**RE: Stone Age Climbing Gym
6200 Alameda NE
Grading & Drainage Plan and Drainage Report
Engineer's Stamp Date: 08/19/19
Hydrology File: C18D086A**

Based upon the information provided in your submittal received 08/19/2019, the Grading & Drainage Plan and Drainage Report **are not** approved for Building Permit. The following comments need to be addressed for approval of the above referenced project:

overall grading
plan
date:
8-19-19
sheet:
c100

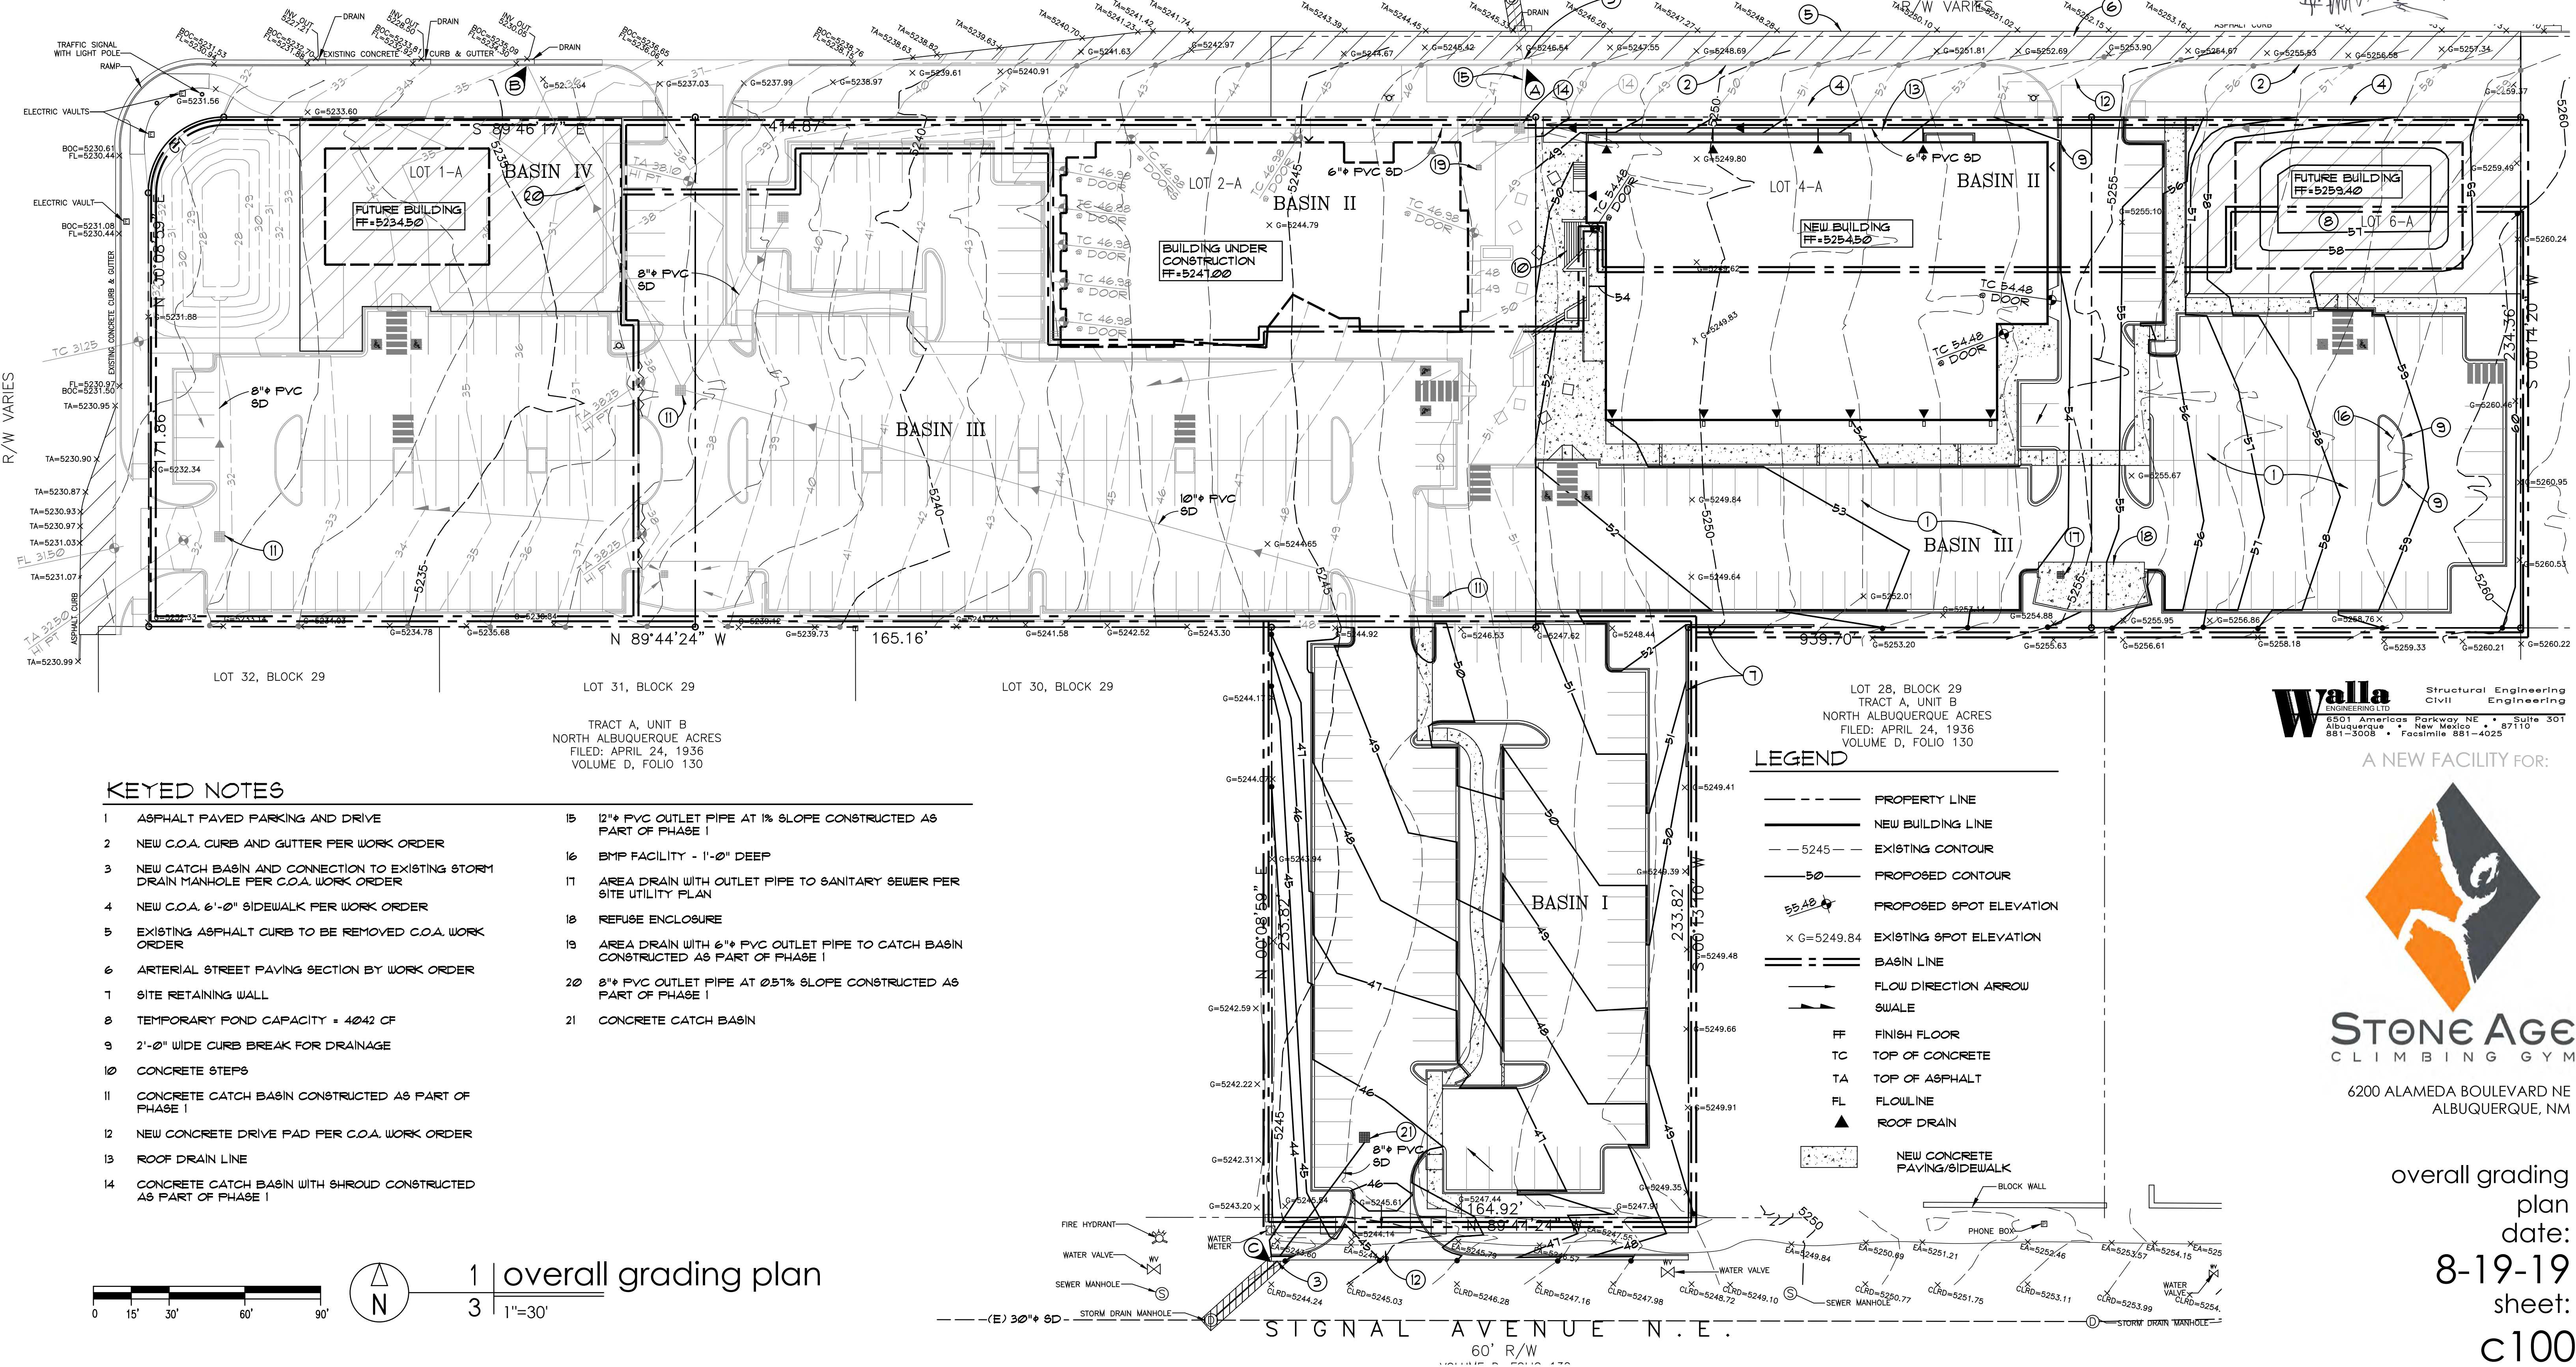
1. Grading & Drainage Plans. There is a temporary retention pond at the area of a future building near the northeast corner of the development. I do not see any purpose for the retention pond. There will be no drainage going into this pond. This area should just be graded for the future pad of the building.

1 | grading and drainage plan
c101 1"=20'

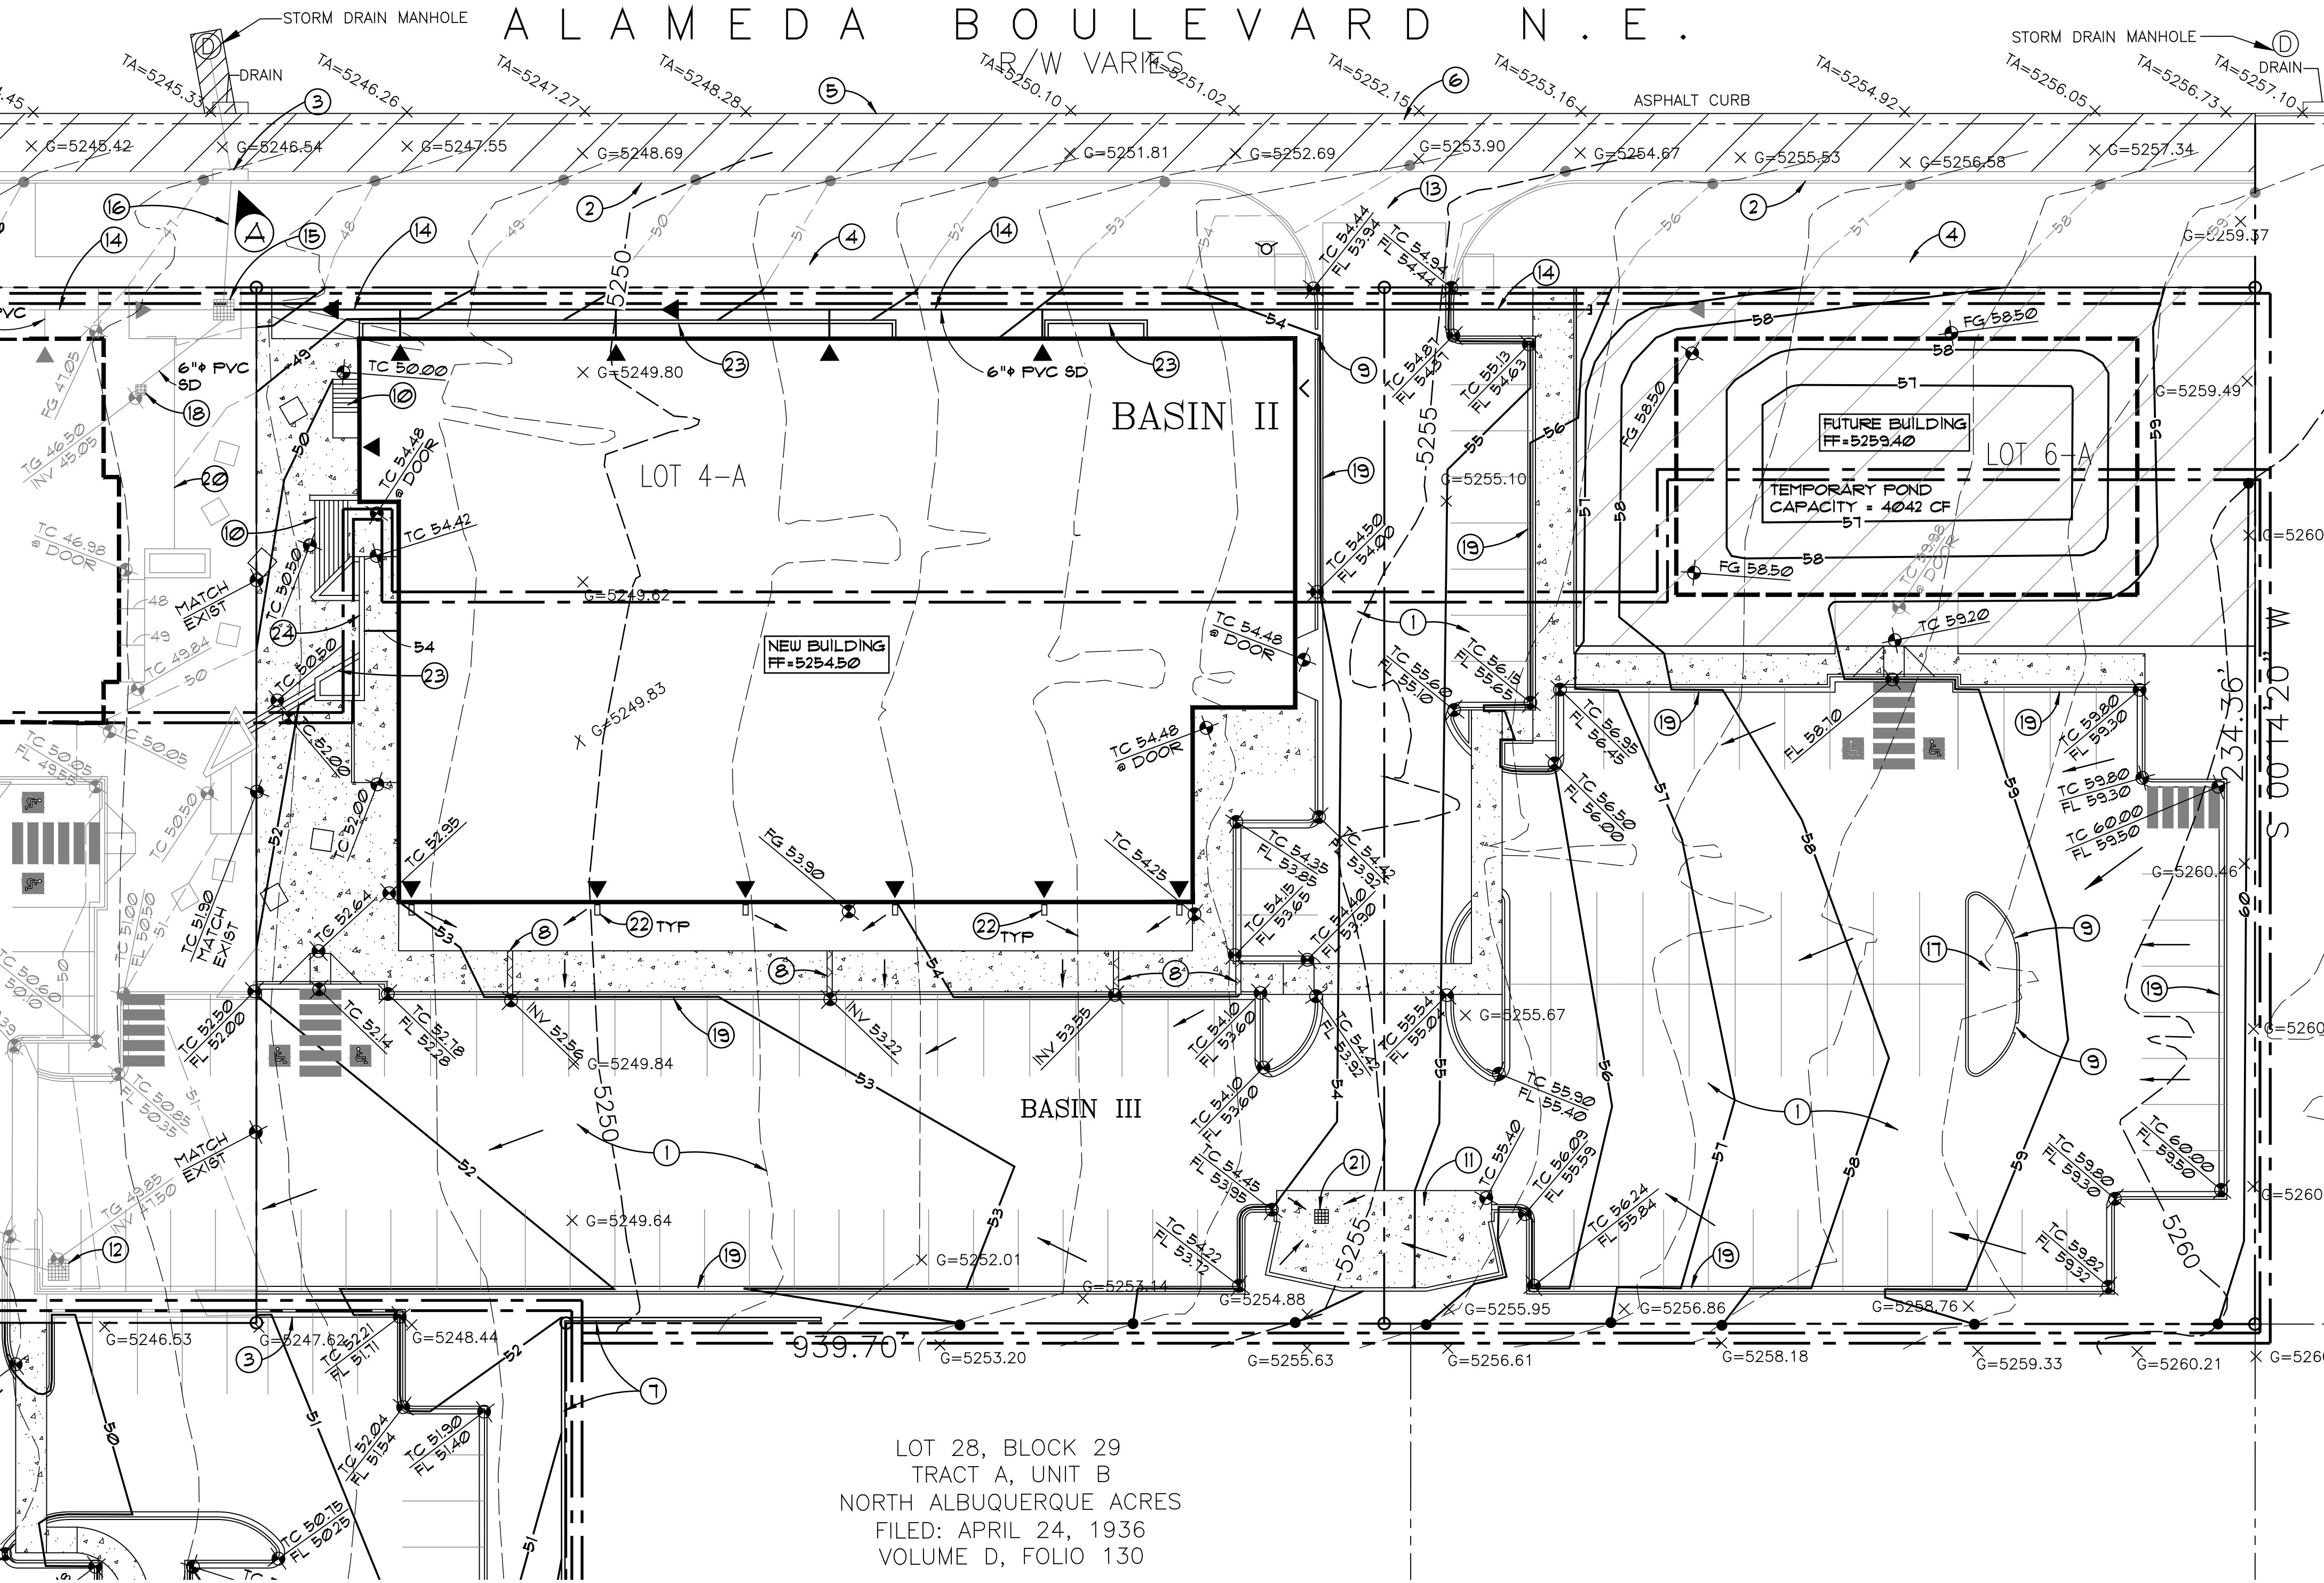
2. Grading & Drainage Plan. Under the Drainage Points, "C" should be 4.02 cfs. This will match the drainage for Basin I in the Ultimate Development.
3. Grading & Drainage Plan. The proposed grate in Basin I is too high and needs to be at the southwest corner of the parking lot. This location is where all the drainage from Basin I is flowing towards. By leaving the inlet as shown, there will be pool of water collecting at the southwest corner of the parking lot. Please fix.
